# Product change notification (PCN)

**Affected products**      STL 950/..-5.0-V(H)-all Colors (-HC) | STLZ 950/..-5.08-V(H)-all Colors (-HC)  
 STL 950/..G-5.0-V(H)-all Colors (-HC) | STLZ 950/..G-5.08-V(H)-all Colors (-HC)  
 STL 950/..F-5.0-V(H)-all Colors (-HC) | STLZ 950/..F-5.08-V(H)-all Colors (-HC)

# Produkt Änderungsmitteilung (PCN)

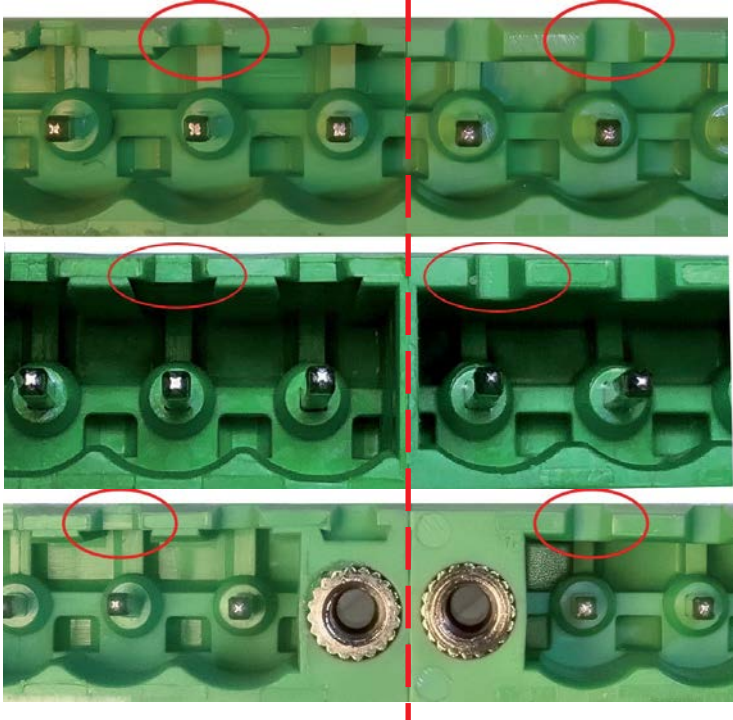
**Einstufung der Änderung** [ ] WICHTIG: Änderung der Zulassungsdaten  
 [X] INFORMATIV: Änderung der Gehäuse-Geometrie | neue Kodiersterne nötig

**Einzelheiten** - Kodiernuten geändert  
 - Änderung bei allen Farbvarianten

ALT		NEU
offene Varianten		offene Varianten
geschlossene Varianten		geschlossene Varianten
Flansch-Varianten	Flansch-Varianten	
 Kodierstern K2 RD Artikel-Nr. 12003.9	 Kodierstern K5 RD Artikel-Nr. 14310.4
